ATTACHMENT 2: RESPONSES TO COMMENTS
Rush Creek Open Space Preserve
Bahia Ridge Fire Road and Trail Improvement Project
Draft Initial Study/Proposed Mitigated Negative Declaration
June 18, 2021

Revised Figure 3: Proposed Project

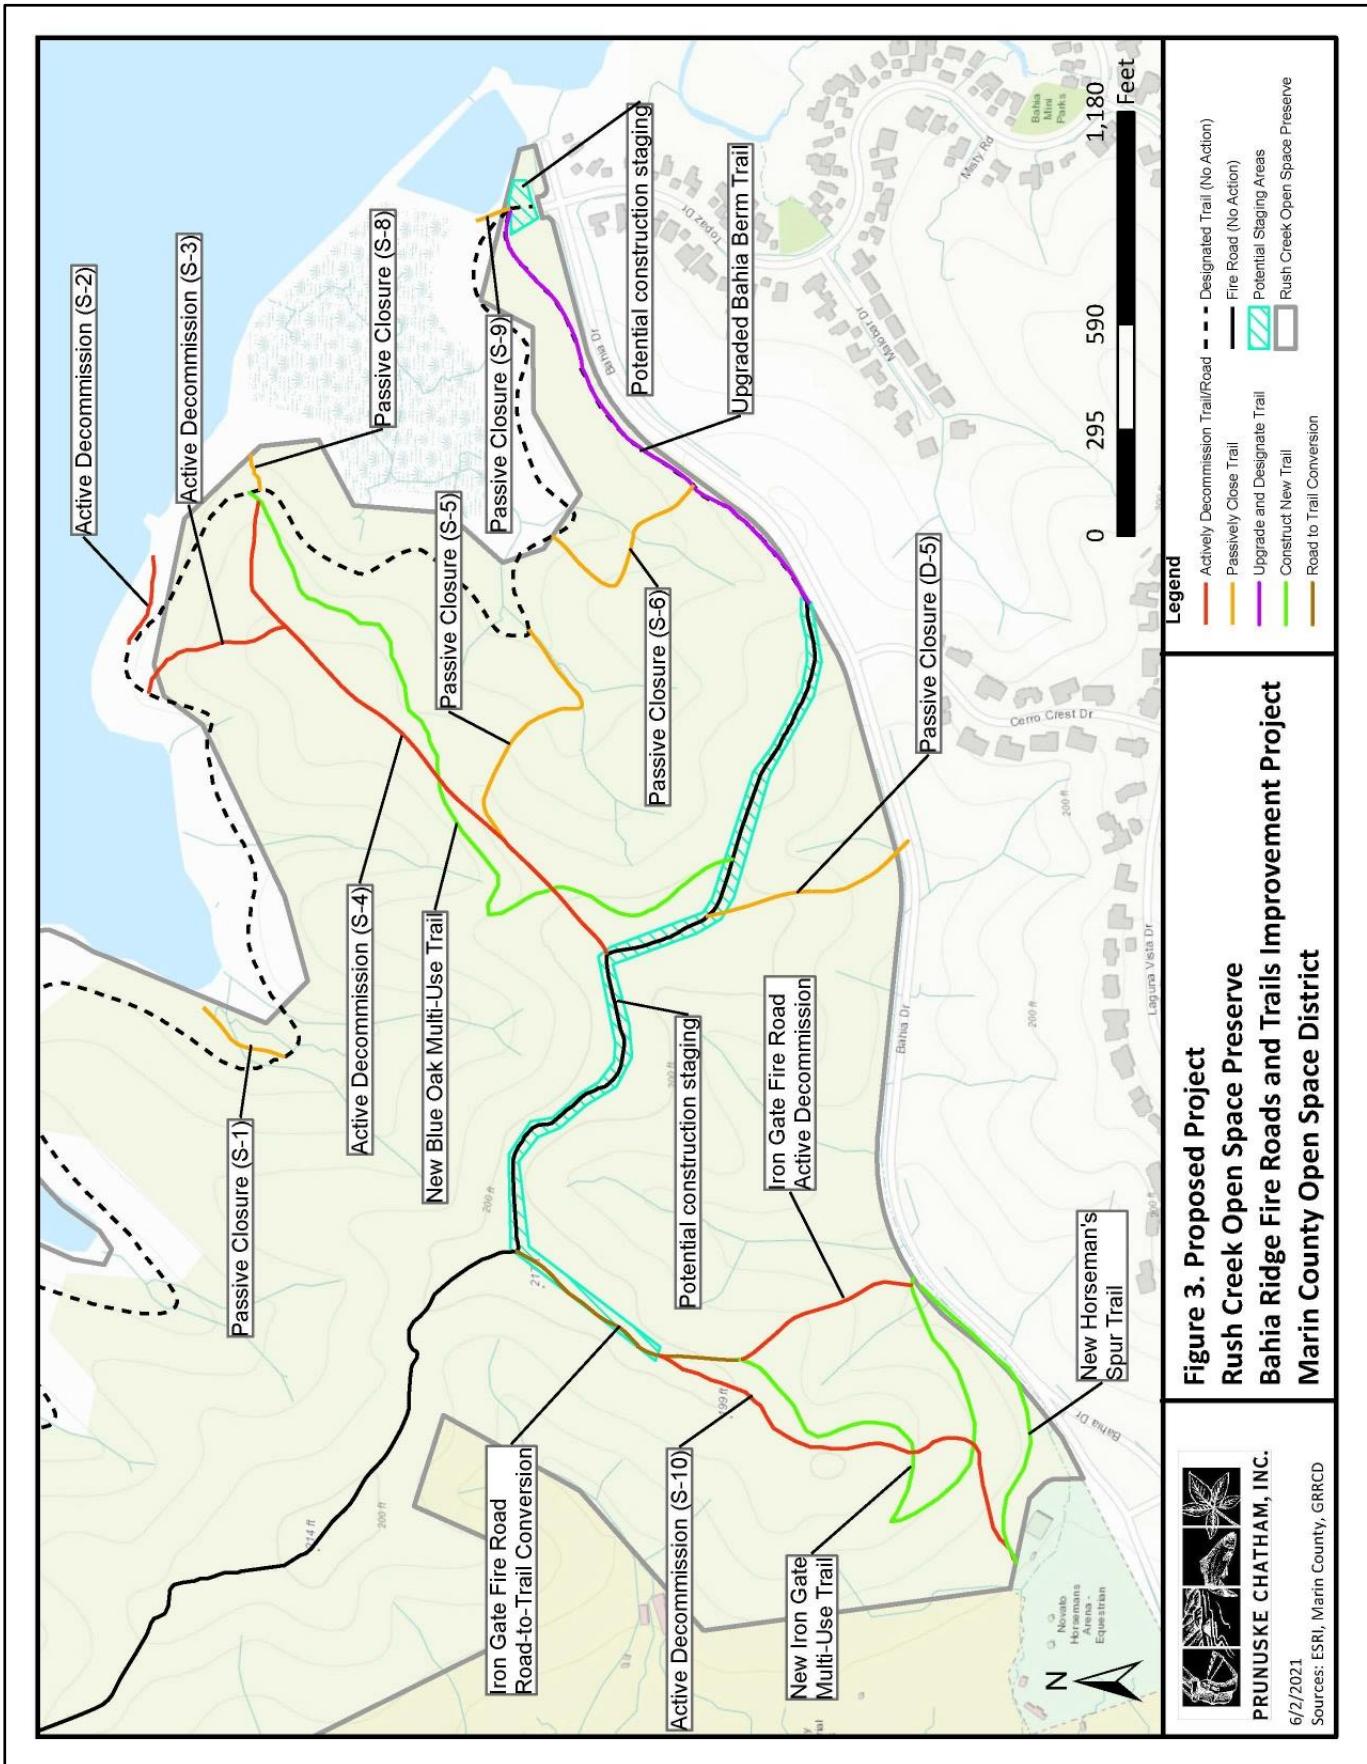
I would like to have a better understanding of exactly where the beginning of the new horseman's spur trail is going to be located at the Novato Horseman's Association. It appears you are moving the beginning of the new spur trail very close to the border of the cemetery.

The New Blue Oak Multi-Use Trail (S 4) would be relocated to the east and west. The current trail is actually not as straight as it is shown on Figure 3. It weaves in an uneven line. We had difficulty finding where the new trail would be located. On our recent visit we saw a few blue and orange ties on trees but it was unclear if they marked the new routes. The slope for the proposed new alignment to the east is steep. We are concerned that this alignment would require deep cuts into the hillside, which could cause damage to tree roots and possible eventual loss. The upper half of the trail would extend to the west into an area that is also sloped although less than on the east. The upper half of the relocated trail makes a jog - not clear to us why. We also observed an area of madrone trees, which we considered rare and worthy of mention and protection. It is not shown on the vegetation figure and it should be.

The trailhead of the proposed Horsemen's Spur Trail at the Novato Horseman's Association ("Association") would be in the same position as the current social trail that extends from Association's property line into Rush Creek Open Space Preserve. From this point the trail will extend further to the east and away from the cemetery property to connect with the Iron Gate Trail near Bahia Drive. Figure 3 in the Initial Study shows the general location of the proposed Horsemen's Spur Trail alignment. The proposed alignment as shown on Figure 3 has been clarified as part of the Responses to Comments.

The proposed Blue Oak Multi-Use Trail would be constructed following decommissioning of social trail S-4 and would provide a multi-use system trail connecting to the Bahia Ridge Trail to the south and the Bahia Trail to the north, as shown on Figure 3 in green. It would be constructed using a curvilinear design generally following the natural contours of the hillslope to allow for installation of permanent and frequent drainage controls along the 7 percent grade trail. The average gradient of the alignment would be below 10 percent, which would result in a sustainable trail from both a soil stability and trail maintenance perspective. No deep cuts would be required to develop the Blue Oak Multi-Use Trail. The alignment was informed by the Biological Assessment prepared by Prunuske Chatham specifically to identify an alignment that would minimize resource impacts. The proposed alignment was discussed and selected through stakeholder meetings including the Environmental Roundtable to avoid higher quality habitat quality, as depicted in Figure 15 – Vegetation Types and Areas of Interest. Figure 15 has been revised as part of the Responses to Comments to include new trails. The proposed Blue Oak Trail alignment was identified to meet sustainability goals by decommissioning steep erosive fall line trails and replace them with low grade trails that would minimize erosion. The proposed Blue Oak Trail alignment considered the significance of the mature forest, specifically the blue oak trees, and no mature trees would be removed to implement the proposed trail alignment and the root zones would not be impacted. The directional changes (jogs) in the proposed Blue Oak Trail alignment would reduce grades and maintain the trail alignment within the area of existing recreational use, leaving the larger areas of habitat undisturbed.

The location of the proposed social trail S-4 decommissioning is shown on Figure 3 in red. The decommissioning would be concentrated at both ends of the trail to reduce chronic erosion from the exposed trail and would include trail closure signage, installation of split rail fencing, decompaction of the trail tread, construction of cross-drains, and installation of erosion control blanket are the proposed active trail decommission measures. Central segments of the closed trail would be allowed to revegetate naturally. The proposed trail decommissioning would reduce existing erosion by recontouring, trail tread decompaction, and cross-drain installation to reestablish drainage patterns and improve infiltration. These measures would eliminate existing erosion problems.

Revised Figure 13: MCOSD Vegetation Zones Map

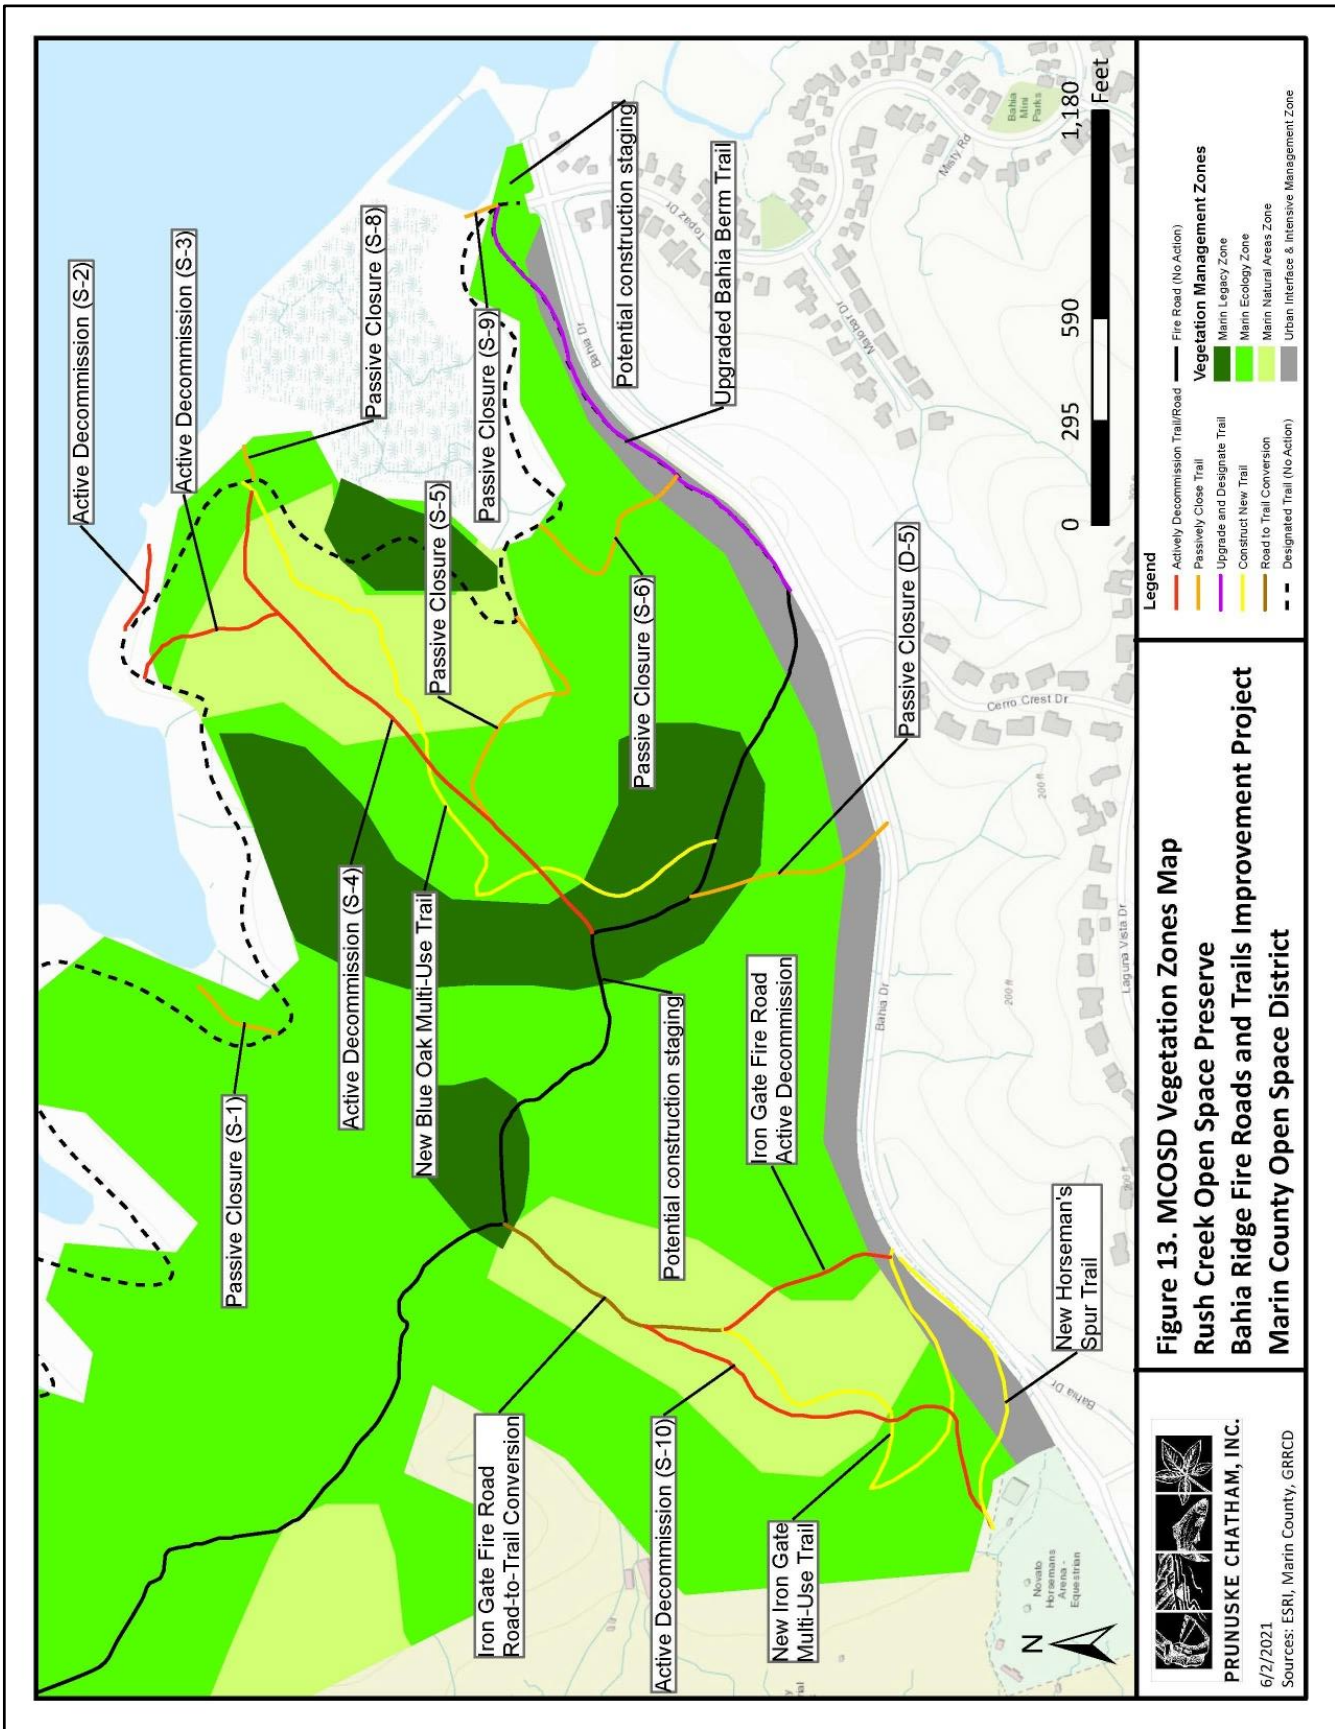
The site contains all four vegetation zones described in the Marin County Vegetation Management Plan: Legacy Zone is the most sensitive zone with undisturbed natural systems, Sustainable Natural Systems, Natural Landscape and Highly Disturbed zone. We can't determine from the information provided whether the relocated trails would extend through the Legacy and/or the Sustainable Natural Systems zones, the two most protective zones in the county's system. If new trails extend through these zones, it would impact the sensitivity of these zones, and wouldn't it result in lowering them to a more disturbed zone? The discussion should cover the impact on the vegetation zones of the trails. If the Legacy and/or Sustainable Natural Systems Zones would be impacted, the discussion should address why the trail cannot be relocated to outside the zones.

- The proposed Spur and Iron Gate Trails and new alignments of the New Blue Oak Multiuse Trail and the Horsemen's should be marked on the ground.
- The IS should contain a figure(s) showing the new trails overlayed on the topographic map so that the steepness of the slopes the new trail would be on can be determined. The impact of the trails on the sloped hillsides and vegetation they support should be discussed also.
- A figure should be included overlaying the proposed new trail alignments on the map showing the Legacy zone and the Sustainable Natural Systems zones.

The S-4 Trail proposed for decommissioning is a former jeep road mostly located within the Sustainable Natural Systems Zone and Natural Landscape Zone, with a very small amount of the trail in Legacy Zone. The proposed Blue Oak Trail will be realigned in a manner that will remain consistent, mostly in Sustainable Natural Systems Zone and Natural Landscape Zone with a very small amount of the trail in Legacy Zone. Legacy Zone data is not specific in nature and is used for an initial evaluation. MCOSD contracted with Prunuske Chatham to obtain more site-specific granular data which superseded the quality and level of data that the Legacy Zone data provided. Utilizing the Prunuske Chatham bioassessment data, staff was able to align the proposed Blue Oak Trail in a manner to avoid the need to remove any mature trees and avoid impacts to sensitive species. Multiple alignments were evaluated over a 2-year period by staff and Environmental Roundtable feedback to minimize natural resource impacts as well as improve trail sustainability and the visitor experience.

The Project Description describes the average slopes for the various proposed new trails and the figures that illustrated their proposed locations included topographic lines. The Existing Setting section describes various aspects of the existing environmental features for each of the trail areas, including topography, vegetation, and hydrology. The potentially significant environmental impacts that could result from implementation and use of the proposed project are analyzed throughout the Environmental Checklist. It is difficult to maintain ground markings where new trails are proposed, and for this reason, MCOSD does not conduct this activity.
